**INTERIM CHANGE NOTICES (ICN) FOR RESOURCE CONSERVATION AND RECOVERY ACT (RCRA) GROUNDWATER (GW) MONITORING PLANS**

ICN - PNNL-11523 R0.1

Document Title: Combination RCRA Groundwater Monitoring Plan for the 216-A-10, 216-A-36B, and 216-A-37-1 PUREX Cribs

<p><b>A.</b>  <b>Document Number:</b> <u>WHC-SD-EN-AP-013</u> <b>Revision Number:</b> <u>1</u>  <b>Document Title:</b> <u>Interim Status Groundwater Monitoring Plan for the 216-B-3 Pond</u>  <b>Document's Original Author:</b> <u>M. D. Sweeney</u></p>	<p><b>Effective Date of ICN:</b> <u>12/10/98</u>  <b>Change Requested by:</b> <u>D.B. Barnett</u></p>
<p><b>B. Action:</b> Make pen-and-ink changes to the Groundwater Monitoring Plan document, as described below in Section D. Attach this ICN to the front of the document.</p>	
<p><b>C. Effect of Change:</b> The groundwater monitoring well network and sampling/analysis procedures are changed according to the description in the attached, revised sections. The frequency of sampling is changed from quarterly to semiannual. This ICN supercedes ICN No. WHC-SD-EN-AP-013.1 R1 dated 01/08/98.</p>	
<p><b>D. Reason for Change/Description of Change:</b> <u>Reason:</u> The Assessment Report for

**Figure 3.1. Facility Layout and Locations of Monitoring Wells for the 216-B-3 Pond System.**

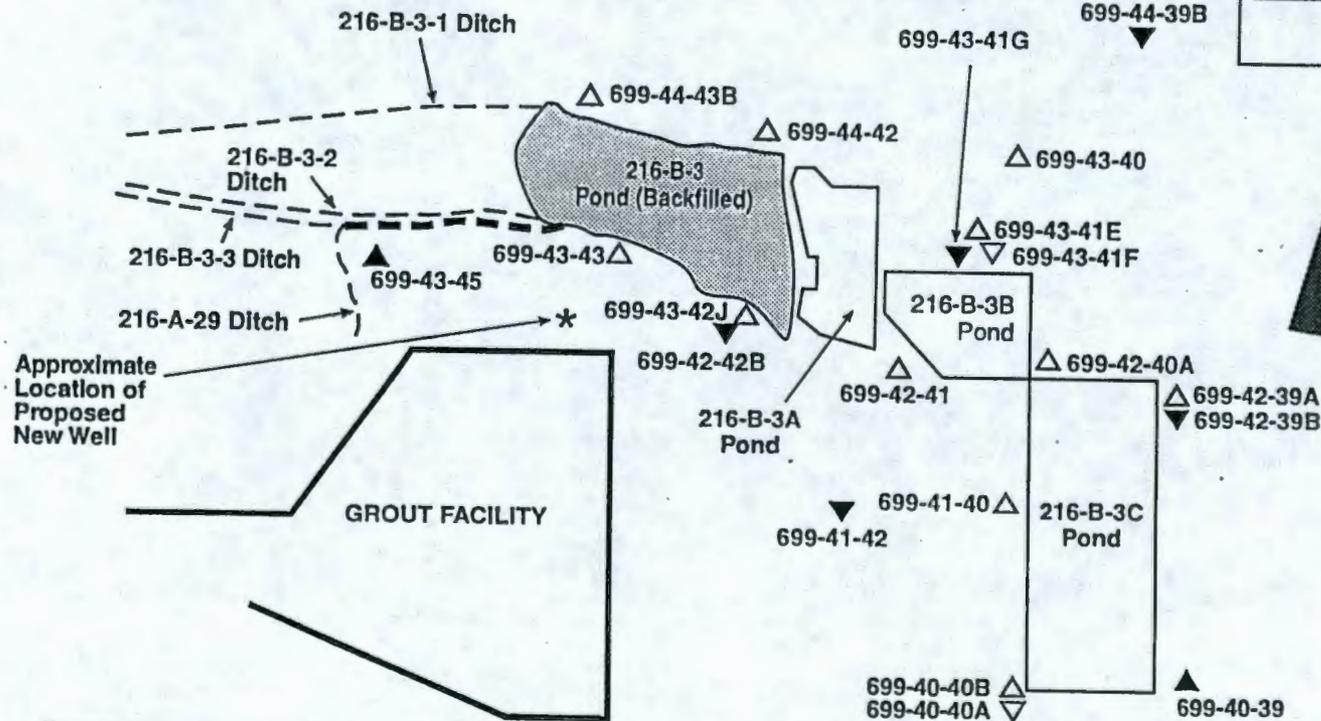
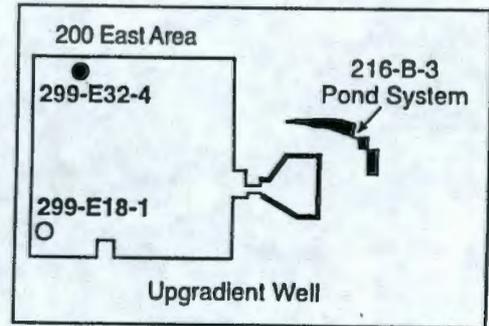
The existing array of wells around the B Pond System provide more than an adequate number of potential monitoring points from which to select. The possible exception is the area immediately southwest of the B Pond, for which a new well is proposed. The revised well network is shown in Figure 3.1. In all, 9 wells (8 downgradient) are proposed for the revised network.

The potential sources of groundwater contamination from the facility and groundwater flow directions (see discussion in Section 3.4.2), indicate that additional monitoring coverage is needed immediately southwest of the main pond. Hence, a RCRA-compliant, downgradient well is proposed for the location shown in Figure 3.1. The well will be screened over an extended interval to accommodate rapidly falling water levels and lengthen the service life of the well, and to intercept contamination at different levels in the aquifer. The well will be drilled to basalt (base of the uppermost aquifer) and screened below the water table. Upon completion, the well will be sampled for the Appendix IX list of constituents, and thereafter for the list of parameters shown in Table 11.
